**CHANCE**  
MANUFACTURING CO., INC.

# Service Information

Ride: ZIPPER

Subject: SEAT SAFETY LUG BOLT CHECK

#### IMPROPER BOLT

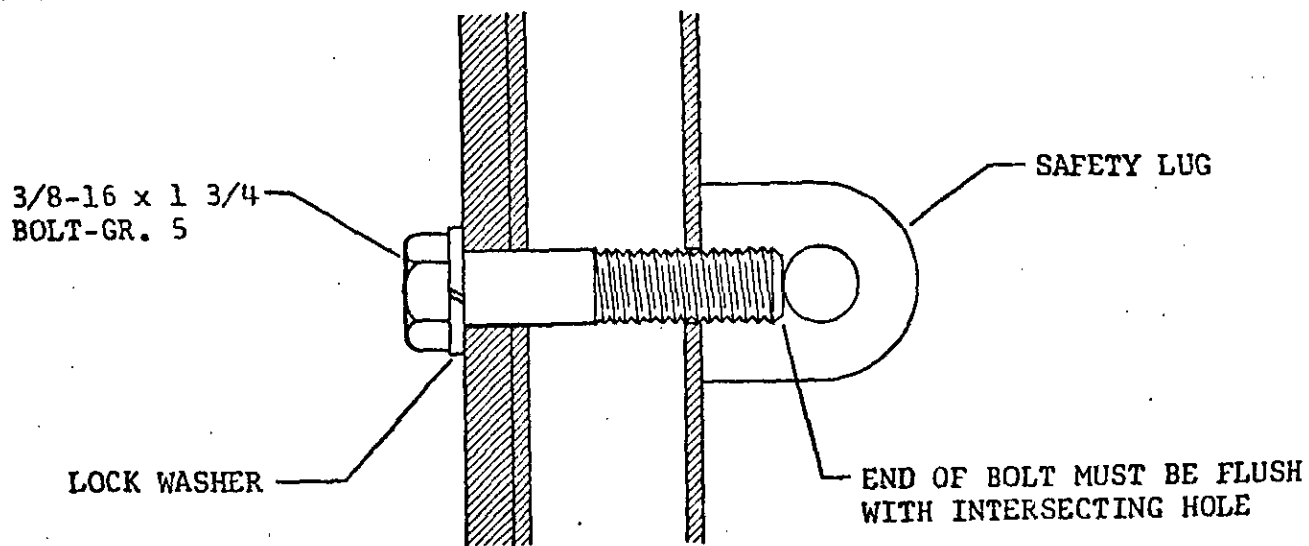
Next, check the grade of the bolt by using the identifying marks on the bolt head.

If the bolt has at least 3 marks on head, it is at least a Grade 5 bolt and is okay.

If the end of the bolt is not visible or is of insufficient grade, it must be replaced.

Remove and discard old bolt. Inspect threads in Safety Lug. If threads appear to be stripping or rounding off, replace the lug and bolt. If threads are okay, replace the bolt. The proper bolt should be a 3/8-16 x 1 3/4 inch long bolt of at least a Grade 5.

FIGURE B

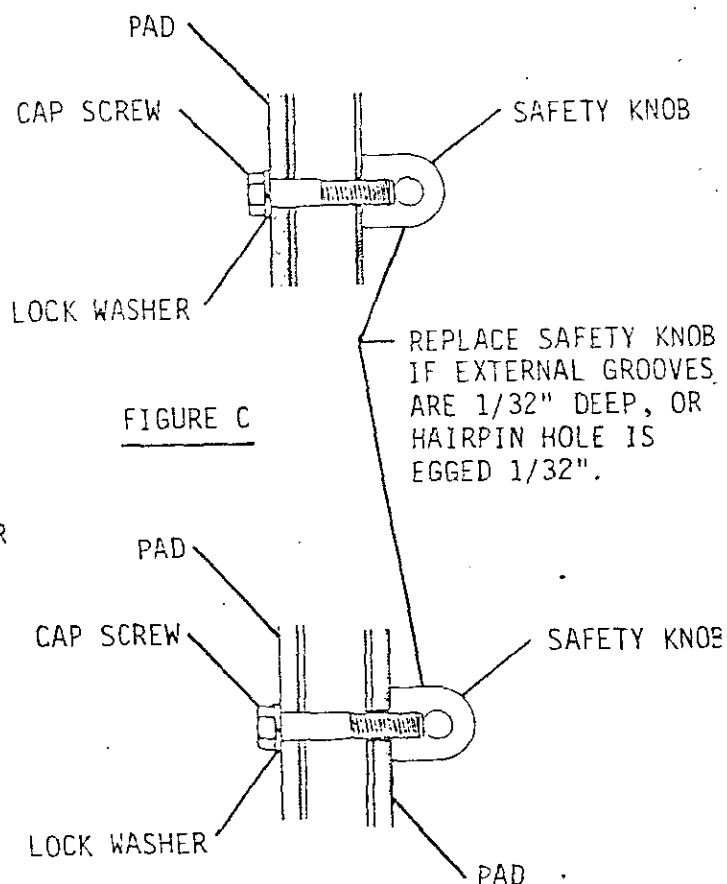
Install the 305-49420 Stricker Plate and 305-49436 Pad on the door. Position the Stricker Plate as shown in figure B. Torque attaching bolts to 15 ft. lbs.

The 390-32497 Spring Latch on each seat must be checked daily. The Spring Latch must be centered on the 305-49420 Striker Plate and should clear the base of the 305-16798 Retainer Clip no more than  $1/16$ " as shown in figure B thus insuring adequate overlap of Spring Latch and Striker Plate and preventing the door from opening unless released by pulling on Spring Latch knob. Spring Latches which clear the base of the Retainer Clip more than  $1/16$  should be replaced immediately and the seat not used until this has been done. (FIGURE B) Do not attempt to straighten or repair the Spring Latch in any way. Each Spring Latch must be replaced on or before the expiration date (month and year) etched at the knob end.

FIGURE B

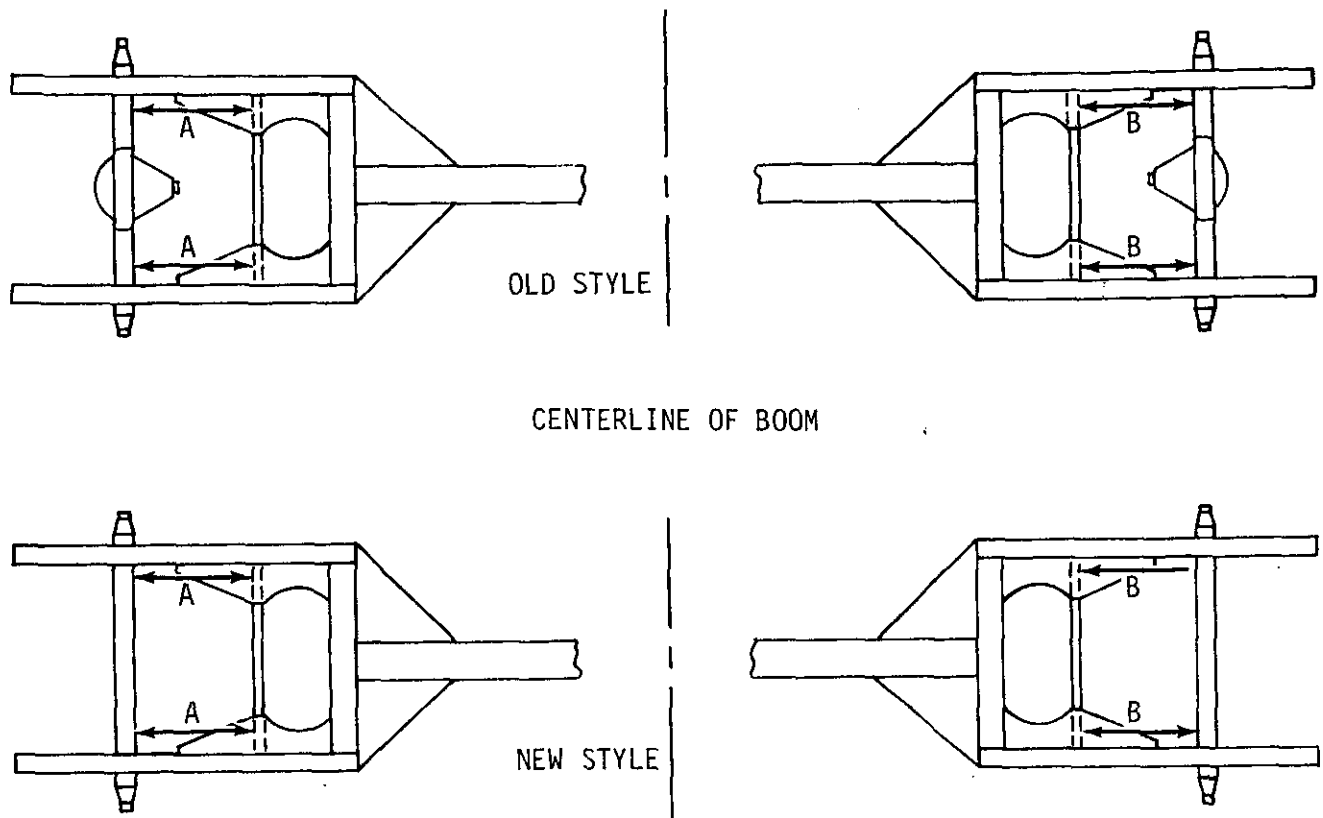
Check the alignment of the seat support axles to see that they are square with one another. Measure and record the distance diagonally both directions (dimensions A and B) between common points on all of the seat support axles. (See Figure A) Measure and record the distance between all of the axles at common points parallel to the drive cables (dimensions C and D). If the C or D dimensions are not consistent, loosen the necessary U-bolt and move the seat support axle as required. Measurements and adjustments must be performed while the seat support axles are at a straight section of track and all of the cross cables have been removed.

If one of the drive cables has slipped the A dimensions will differ from the B dimensions, but the C and D dimensions will be the same. To correct this, install one cross rod at dimension A or B which ever is the longest (See Figure B) and tighten the cross rod. "Jog" the drive cables by running the cable drive first one direction and then the other for a few inches. Tighten the cross rod and repeat procedure until the A and B dimensions are the same.

FIGURE D

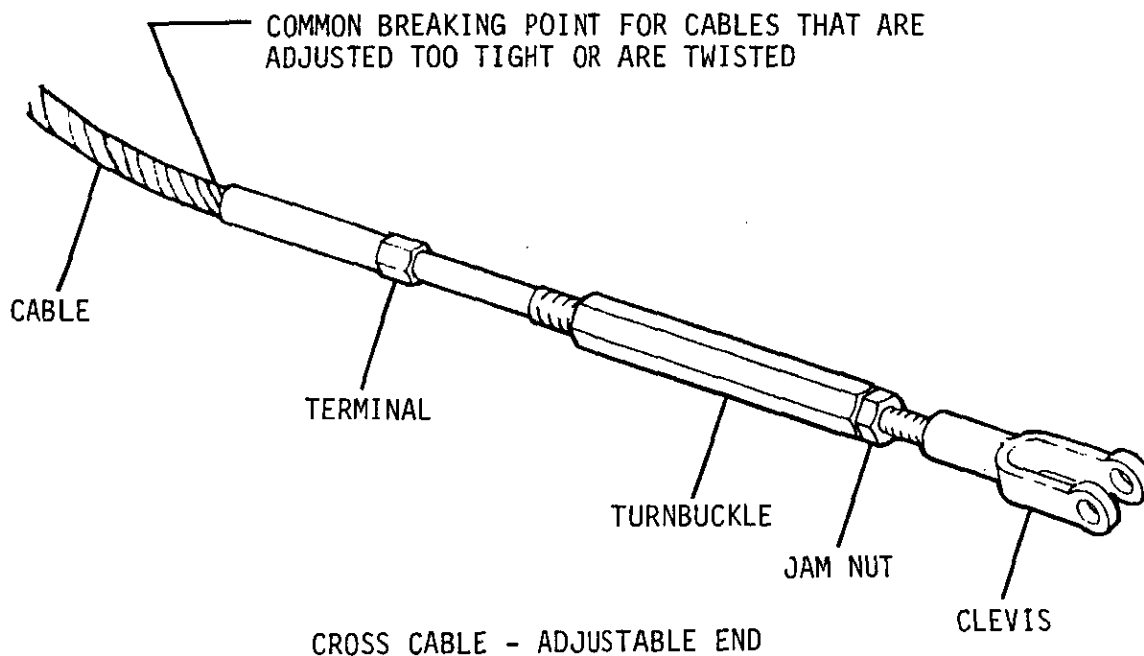
Cross tie rods must be used when setting up or tearing down the ride to help keep the seat support axles in alignment during these operations.

FIGURE A

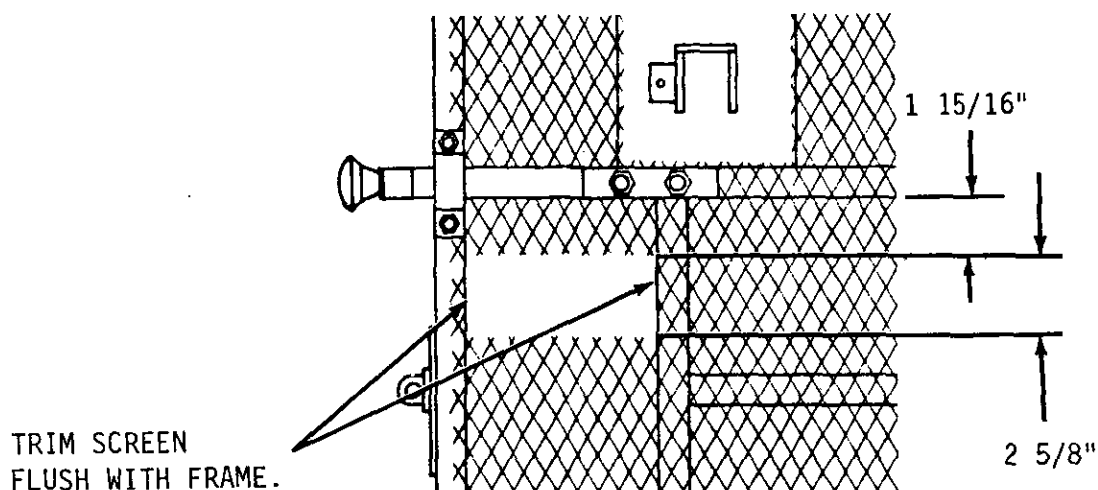
Remove screening from area shown in FIGURE A.

FIGURE B

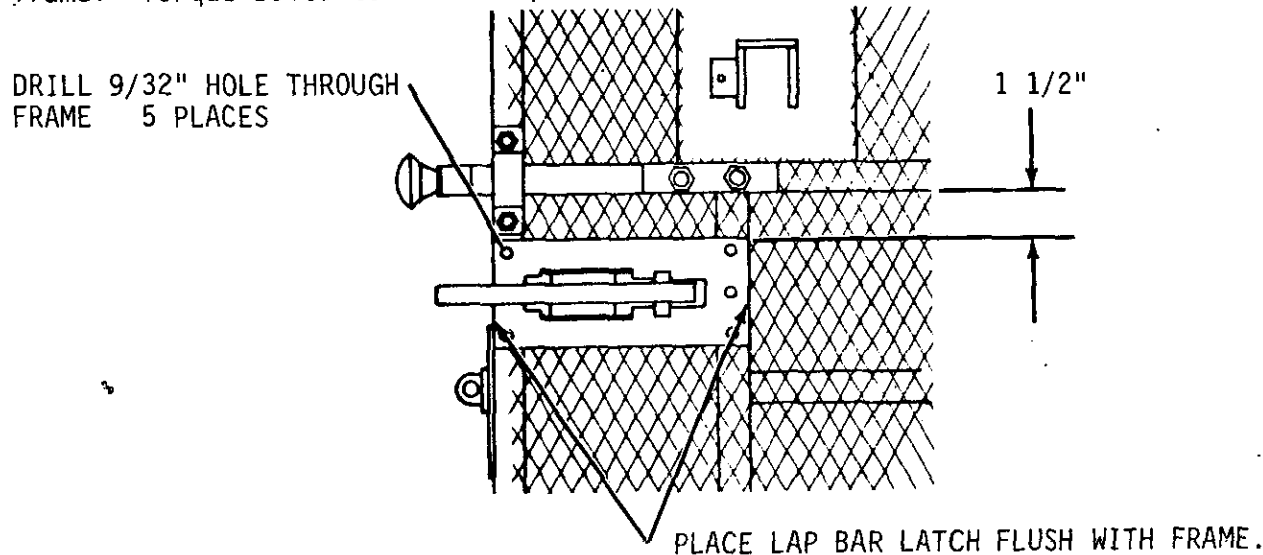
Place the 305-39677 Lap Bar Latch in position as shown in FIGURE B. Use Lap Bar Latch as a pattern and drill the attaching holes through frame in 5 places using a 9/32\"

Attach Lap Bar Latch to frame with 1/4-20 X 1 3/4\" bolts and lock nuts. Insert bolts with 1/4\" flat washers under head and with nuts on the outside of the frame. Torque bolts to 72 inch pounds.

Both right and left hand Lap Bar Latch included in this kit. Install Lap Bar Latch so that the heads of the Socket Head Shoulder Bolt and the Clevis Pin are on the top side of the Lap Bar Latch.

FIGURE C

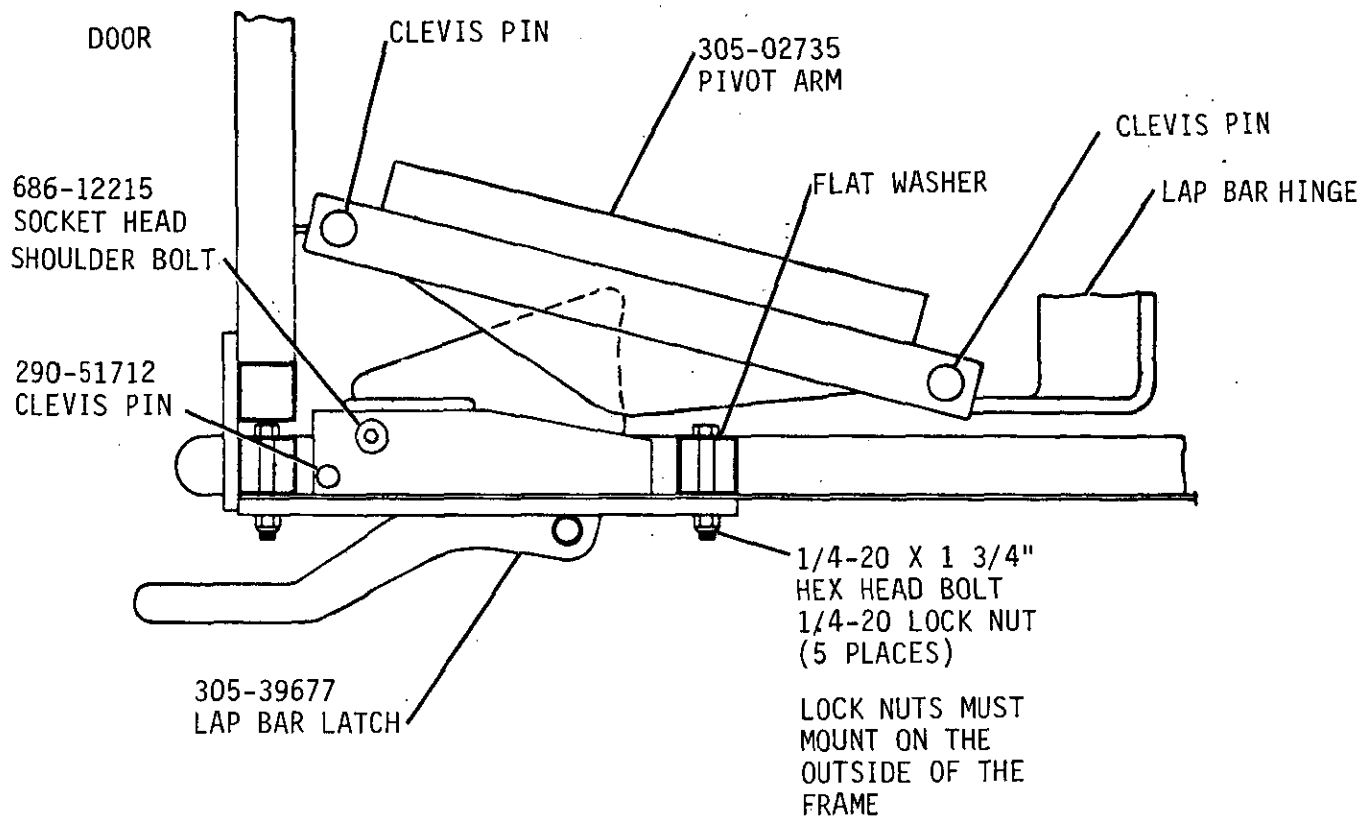
Lap Bar Latch must overlap Lap Bar Hinge a minimum of 1/2".

FIGURE F

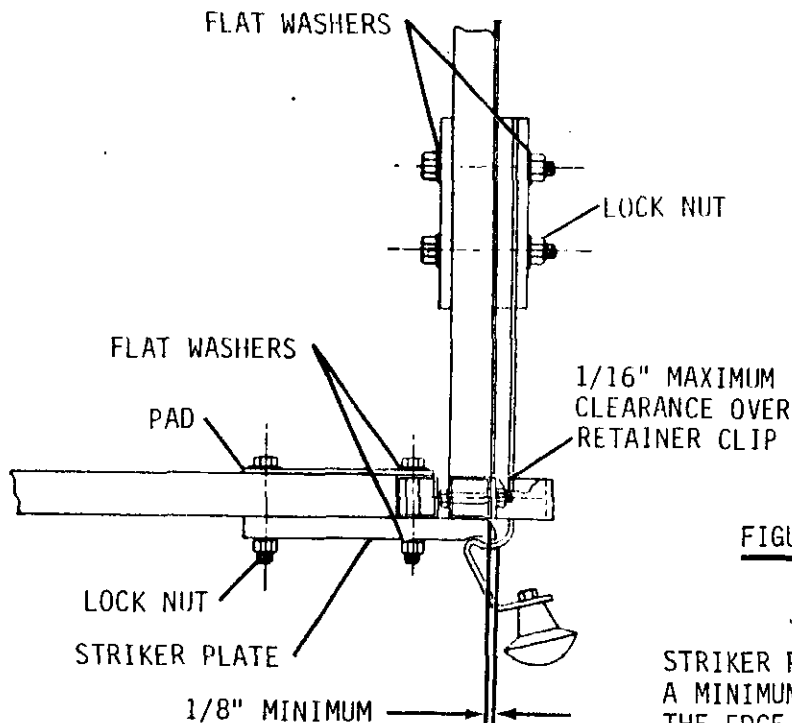
The 390-32497 Spring Latch must be centered on the 305-49420 Striker Plate and should clear the base of the 305-16798 Retainer Clip no more than 1/16" as shown in Figure F, thus insuring adequate overlap of Spring Latch and Striker Plate and preventing the door from opening unless released by pulling on Spring Latch knob. Spring Latches which clear the base of the Retainer Clip more than 1/16" should be replaced immediately and the seat not used until this has been done. (FIGURE F). Do not attempt to straighten or repair the Spring Latch in any way. Each Spring Latch must be replaced on or before the expiration date (month and year) etched at the knob end. Attaching bolts must be retorqued if found loose.

STRIKER PLATE MUST EXTEND  
A MINIMUM OF 1/8" BEYOND  
THE EDGE OF THE FRAME.

FIGURE J

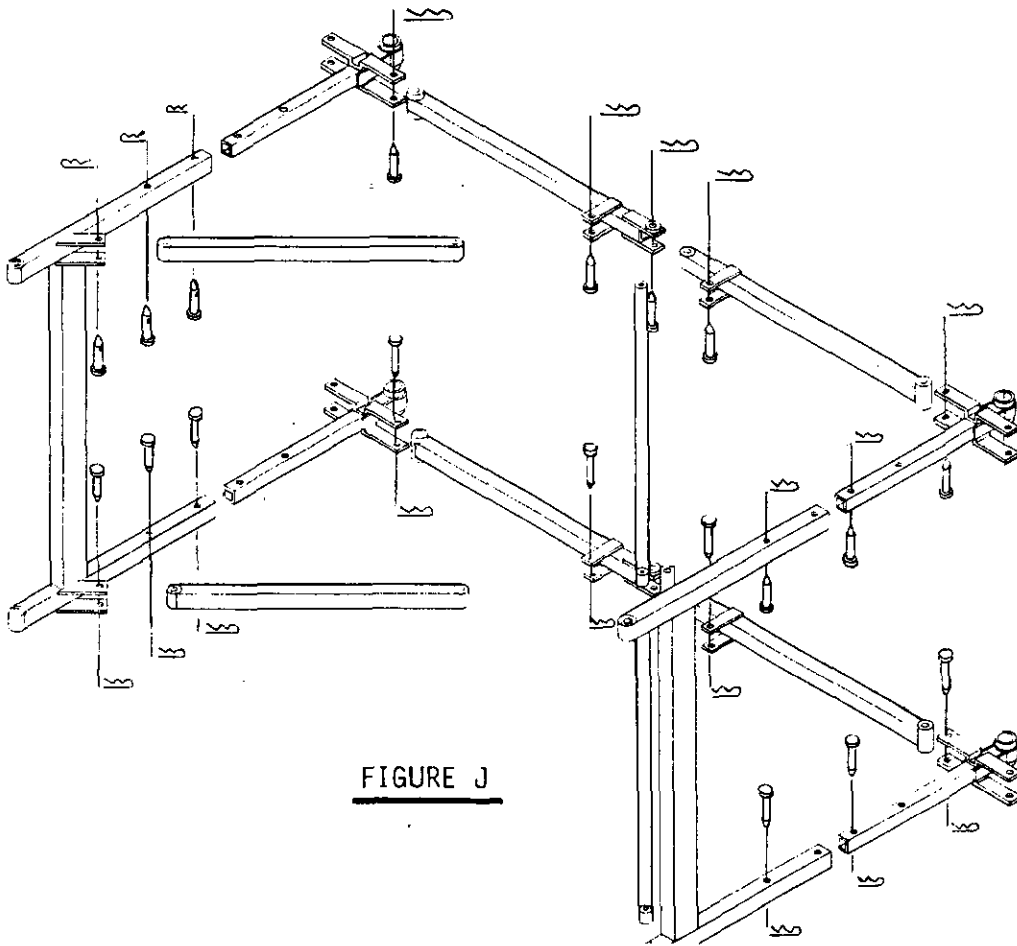
Inspect all taper pins in seat support frame. Taper pin must always be inserted so that the heads of pins are to the inside of the frame to provide maximum seat clearance.

FIGURE A

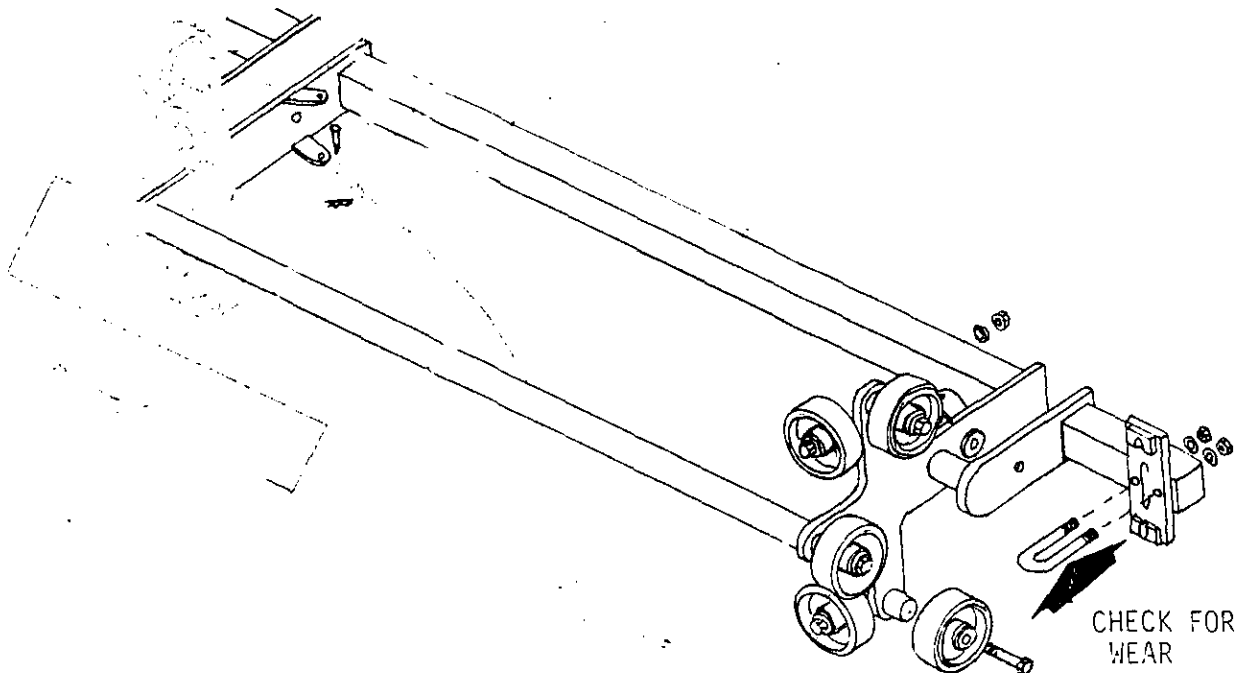
As a safety precaution, all Zipper owners are being asked to inspect all cable clamp "U" bolts (See Figure A).

Please inspect all clamps for signs of wear and notify Chance Manufacturing if such a condition exists.

FIGURE A

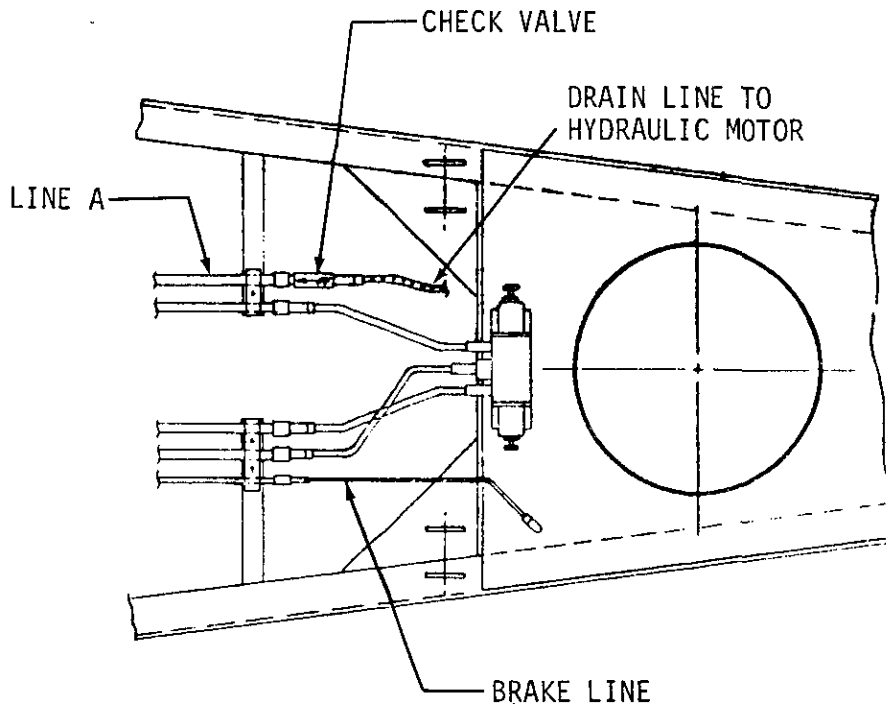
Inspect hydraulic plumbing for check valve position as shown in FIGURE A.

If this check valve is not in position shown, contact Chance Manufacturing Co. for instructions in replacement.

FIGURE B

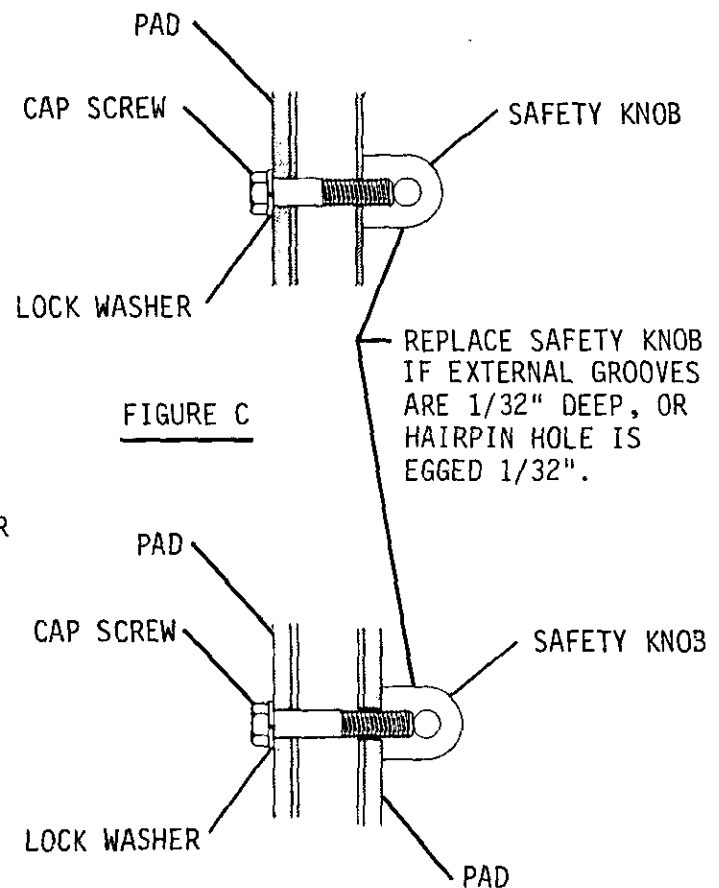
Install the 305-49420 Stricker Plate and 305-49436 Pad on the door. Position the Stricker Plate as shown in figure B. Torque attaching bolts to 15 ft. lbs.

When installed, the striker plate should extend a minimum of 1/8" beyond the edge of the frame.

The 390-32497 Spring Latch on each seat must be checked daily. The Spring Latch must be centered on the 305-49420 Striker Plate and should clear the base of the 305-16798 Retainer Clip no more than  $1/16$ " as shown in figure B thus insuring adequate overlap of Spring Latch and Striker Plate and preventing the door from opening unless released by pulling on Spring Latch knob. Spring Latches which clear the base of the Retainer Clip more than  $1/16$  should be replaced immediately and the seat not used until this has been done.(FIGURE B) Do not attempt to straighten or repair the Spring Latch in any way. Each Spring Latch must be replaced on or before the expiration date (month and year) etched at the knob end.

ILLUSTRATION B

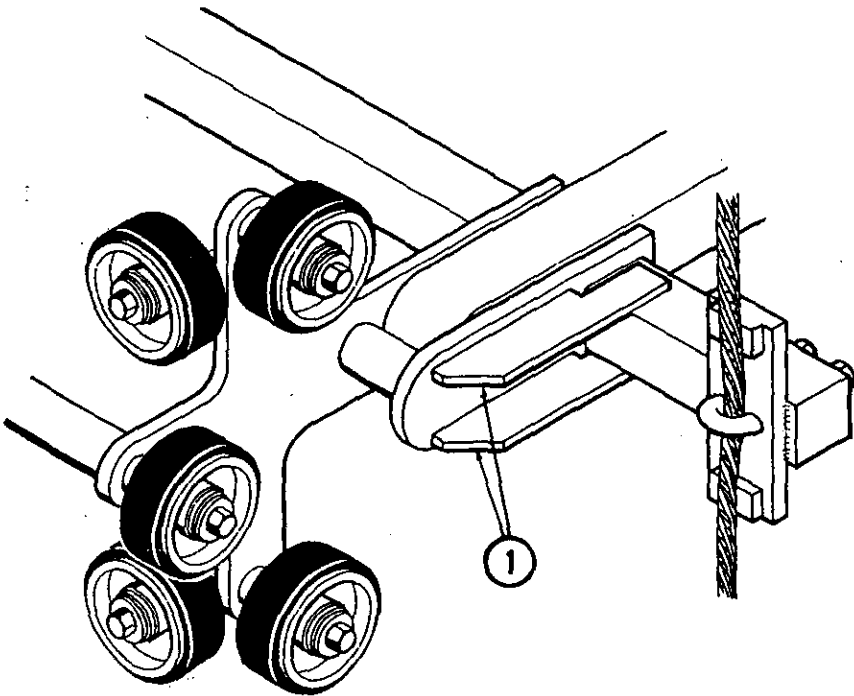
If cracks are found, replace the axle frame with a new part. Do not attempt to weld or otherwise repair a cracked axle frame. Order part number 305-03240 for a new axle frame weldment (does not include wheels).

Install kit no. K05-0350-00 as shown in Illustrations B and C. Two plates must be added to each end of every axle frame.
